MIDTOWN COLLECTION AT HANNAH RIDGE			
FILING NO. 1			
STREET IMPROVEMENT PLANS			
JAZZY LADY COURT / HORSEMANSHIP COURT			
DESIGNED BY	JRH	SCALE	DATE
DRAWN BY	JRH	(H) 1" = 50'	SHEET 7 OF 20
CHECKED BY	JRH	(V) 1" = 5'	JOB NO. 1116.30

**MIDTOWN COLLECTION AT HANNAH RIDGE**  
FILING NO. 1  
STREET IMPROVEMENT PLANS  
GRAND PRIX COURT

SF-19-007

3'x3' OUTLET BOX ORIFICE PLATE

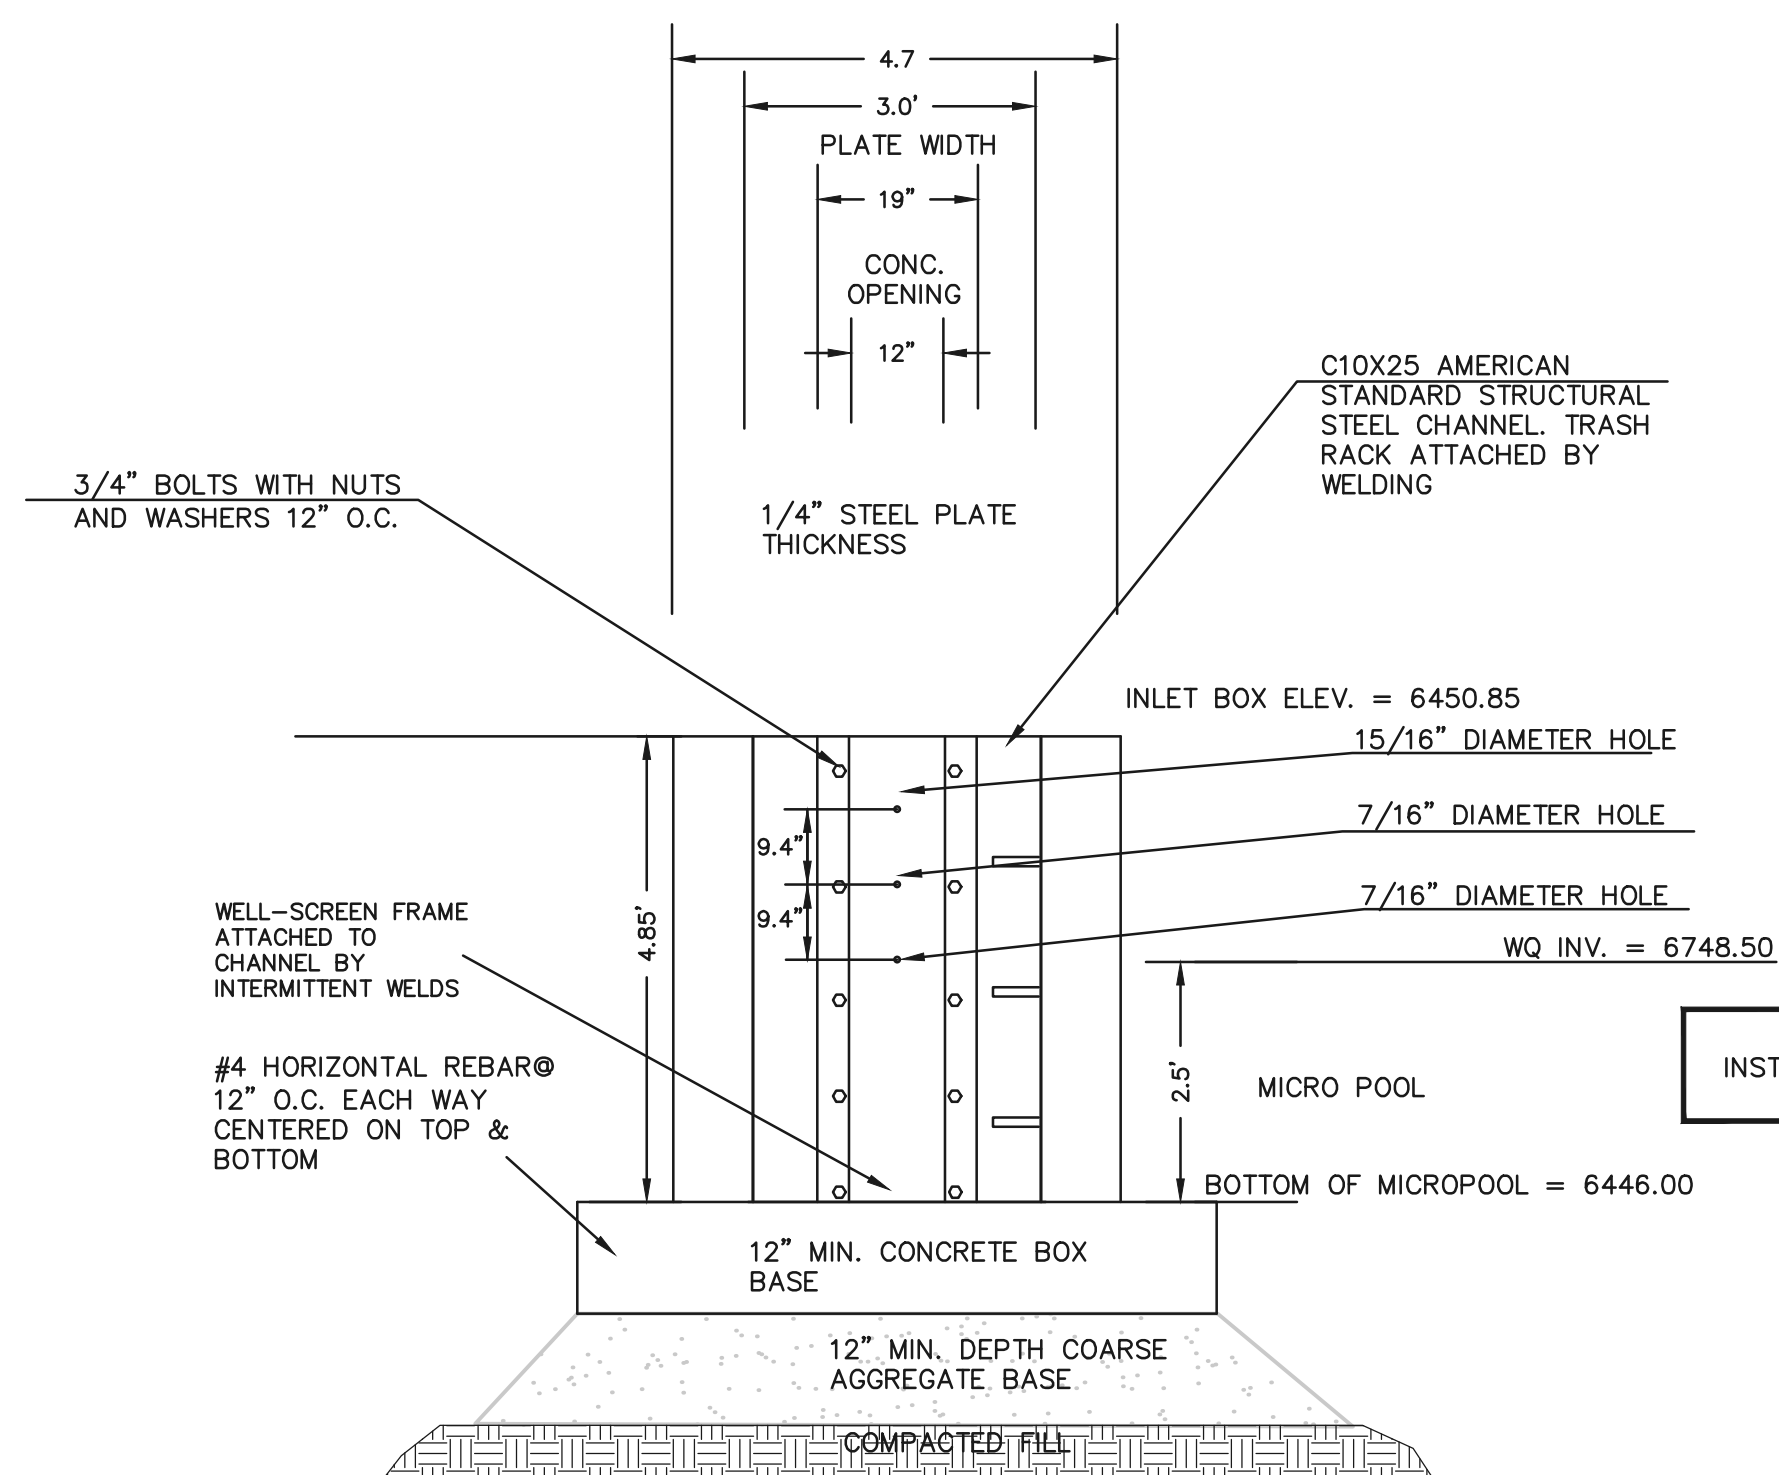
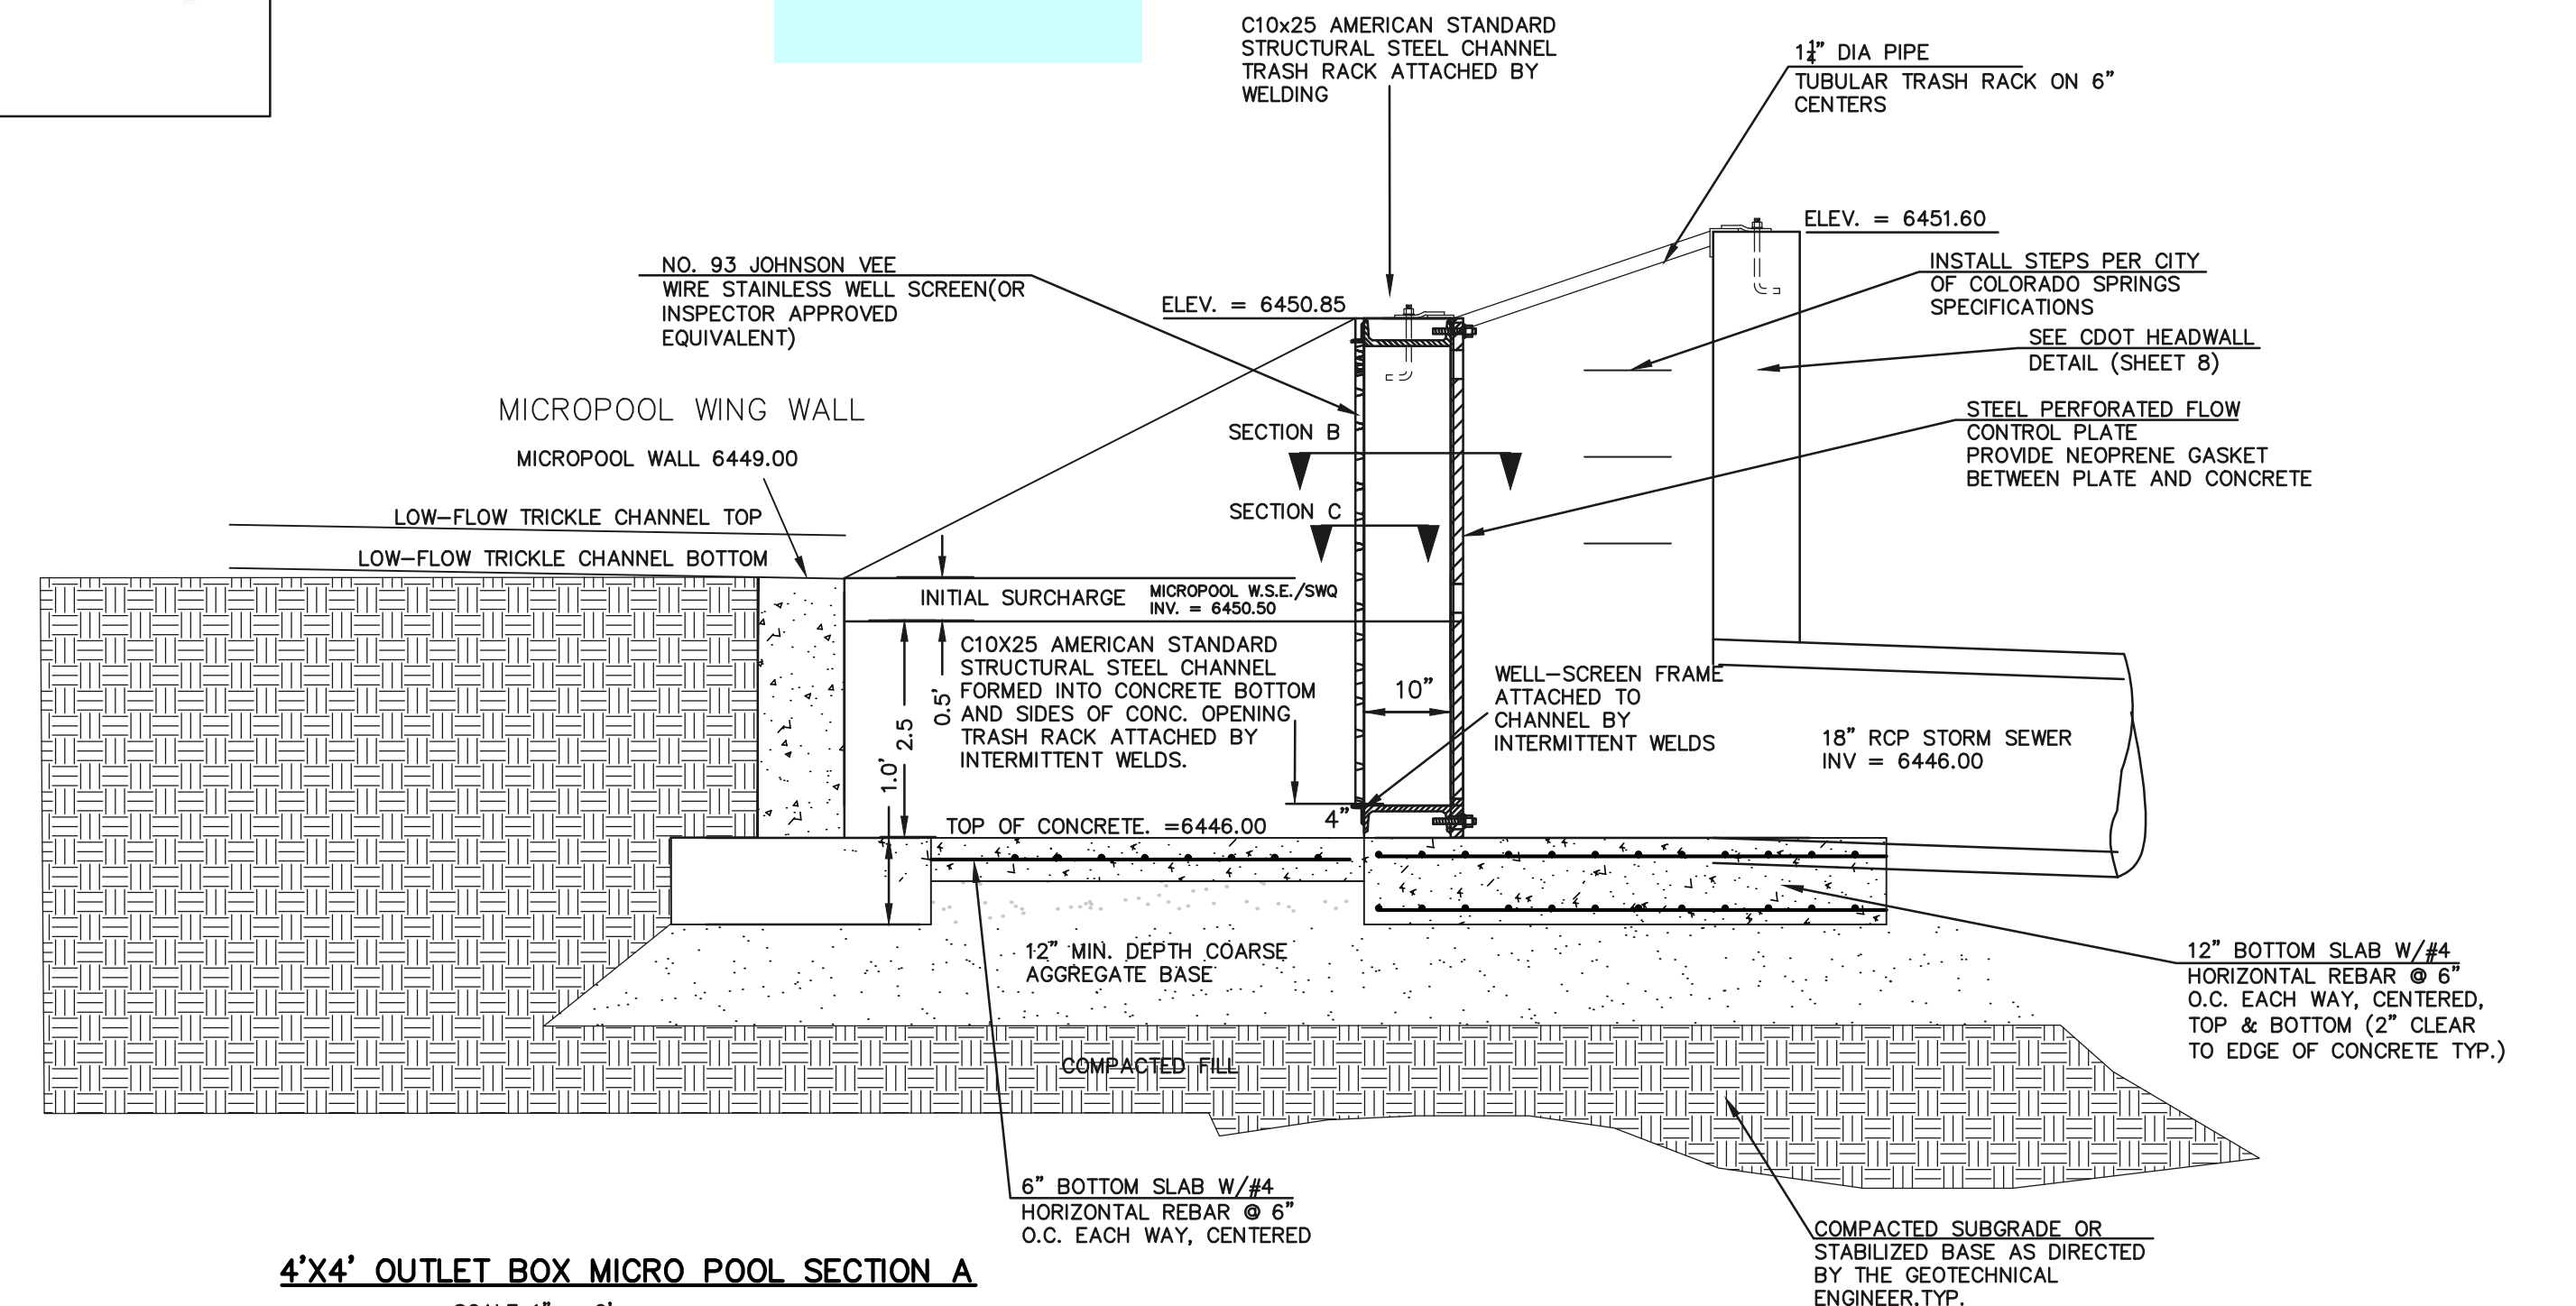
Call out the 100-Yr. WSE & the EURV. WSE

Include a note as to why the designer chose not to use a restrictor plate on the 18" outlet pipe.
